ACP ref : PCX19. 324161

re: Proposed wind farm of 15 wind turbines, a permanent 220kV on-site substation and associated infrastructure.
Applicant : Lemanaghan Wind Farm DAC

I am retained by Séamus Corcoran, Leamonaghan, Ballycomber, Co. Offaly R35 DN40 who makes third party submission/observation in this SID application PXC19. 324161 Attached is the third party submission/observation fee €50-00. Set out below are my client's comments.

Figure 3-1: Proposed Access Route

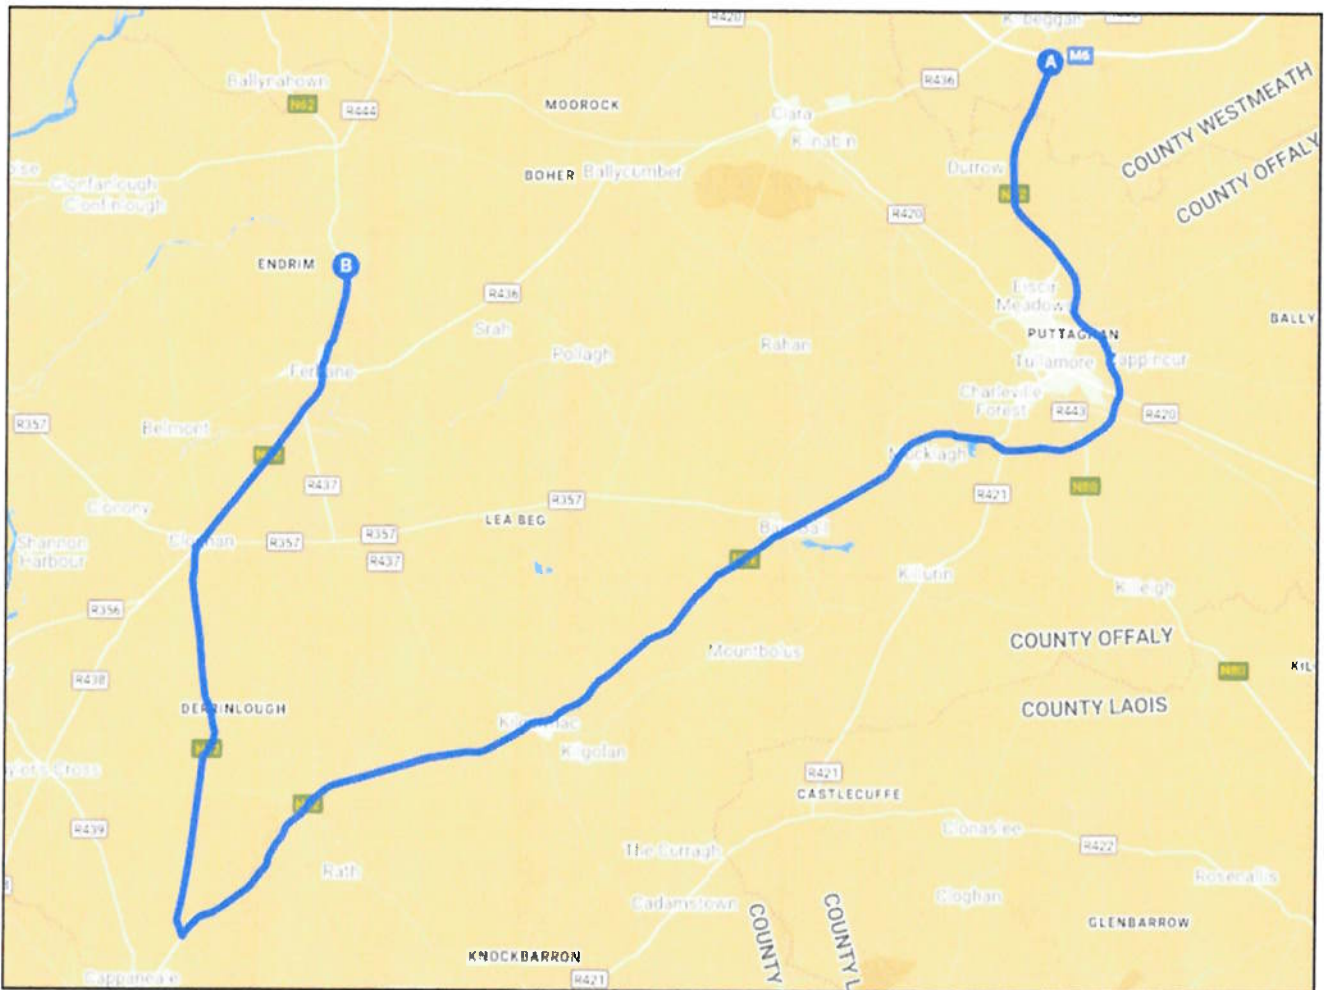
- (i) how do the turbines get to the M6 in the first place ?
- (ii) This is only a half-route.
- (iii) Bord na Mona – not Consultant Pell Freishmann [PF] - selected the route.
- (iv) only a half- route is being considered/assessed

On-line review of a single Land Registry Tailte Eireann Folio takes about 60 seconds. What has been presented is a half-route from the M6 and the half-route folio title has not been checked. Hugely significant is the attached Pell Frischmann page 14 :
"Additional third-party land uptake is required in multiple locations along the route to enable delivery of the loads."

- 1.3 There is little point in seeking Permission for a Wind Farm if the turbines can't be lawfully brought onto the site. Without access across third party land, turbines cannot be brought along the route shown in Appendix 4-7.

- 1.4 Importantly EIAR Appendix 4-7 does not map alternative routes - or half-routes. The failure to consider alternatives is a fatal *lacuna*.

Figure A12-1 Omni Directional noise prediction contour V150 145m HH

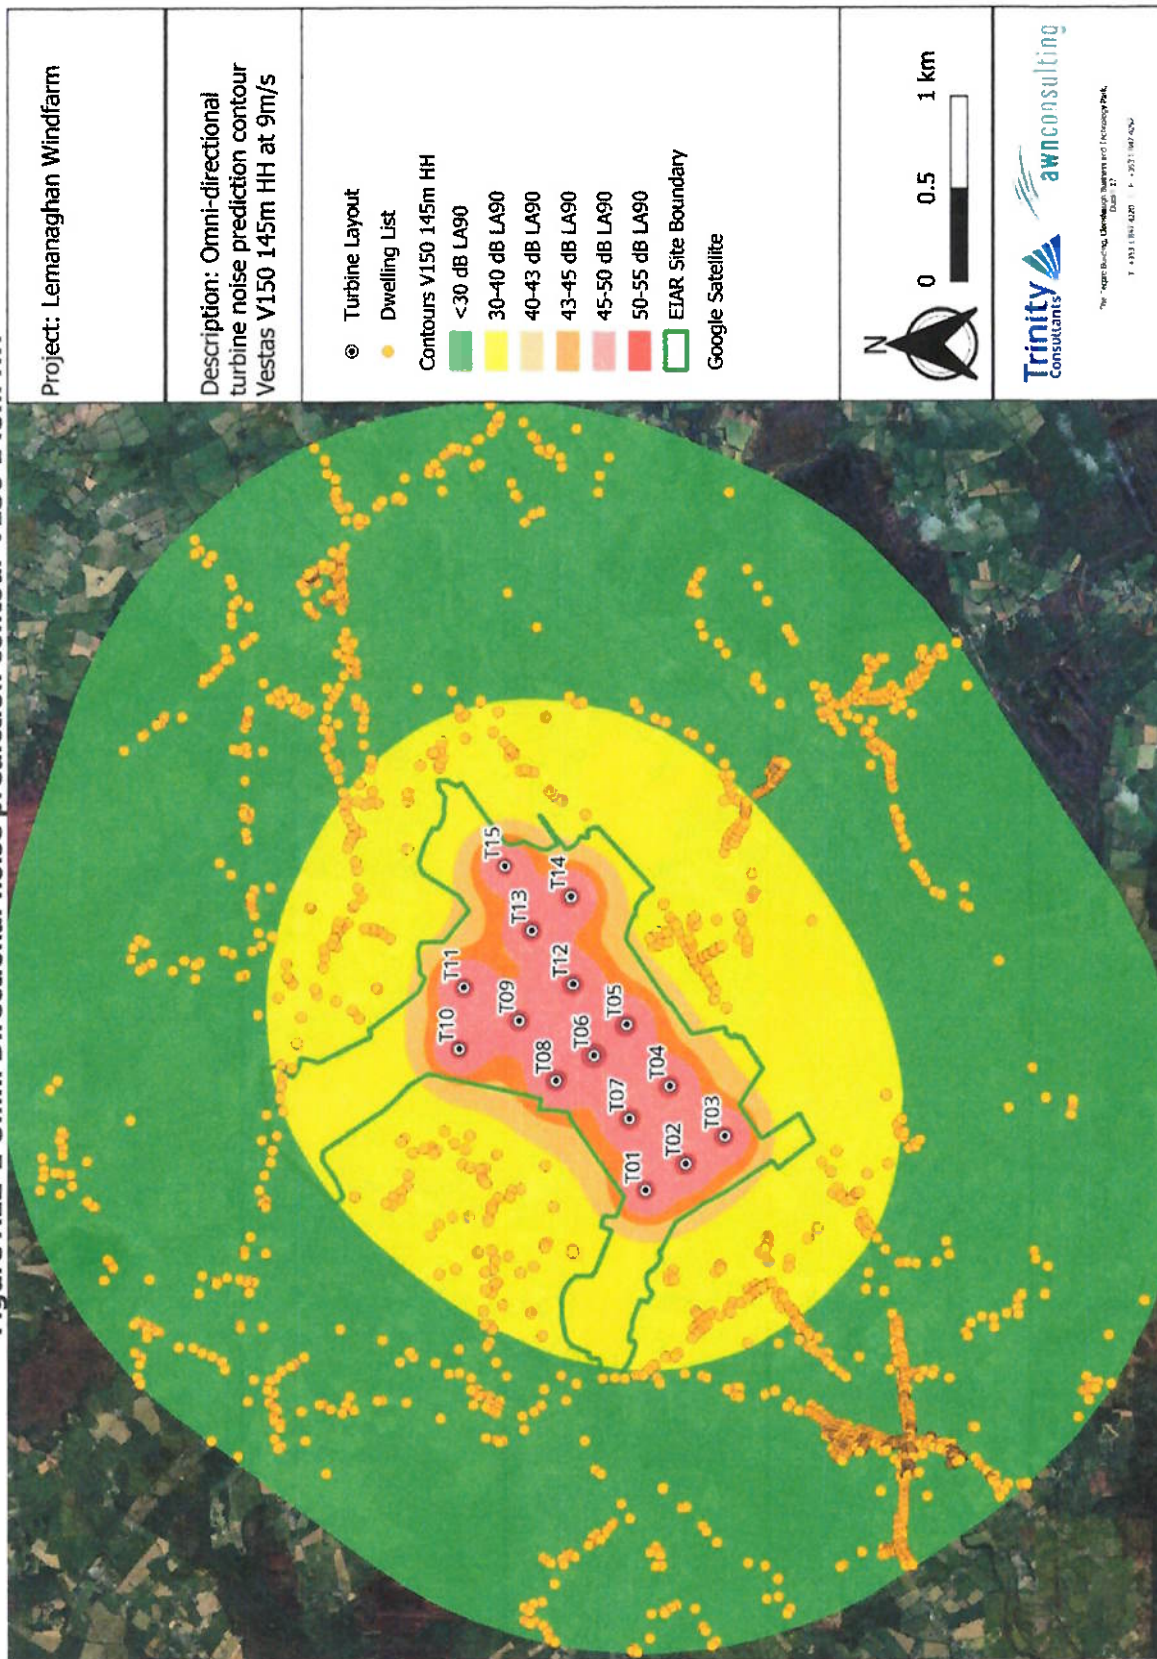
Figure A12-1 Grid Contour Map is a very useful.
The c. 200 dwellings lie in the GREEN <30dB and YELLOW 30-40dB areas.
(The dB levels are contested by the Vesta 150 spec. which recite 105 dB optimised.)
Attachment No. 5(iii)
90% of pipistrelle Bats are within the RED areas.

The dB levels are also contested as Bats hearing range differs from human range and the air turbulence from rotating turbine blade was not assessed.
Moreover the human range was assessed against 10 degrees C and 70% Relative Humidity. What about other temperatures and RHs ?
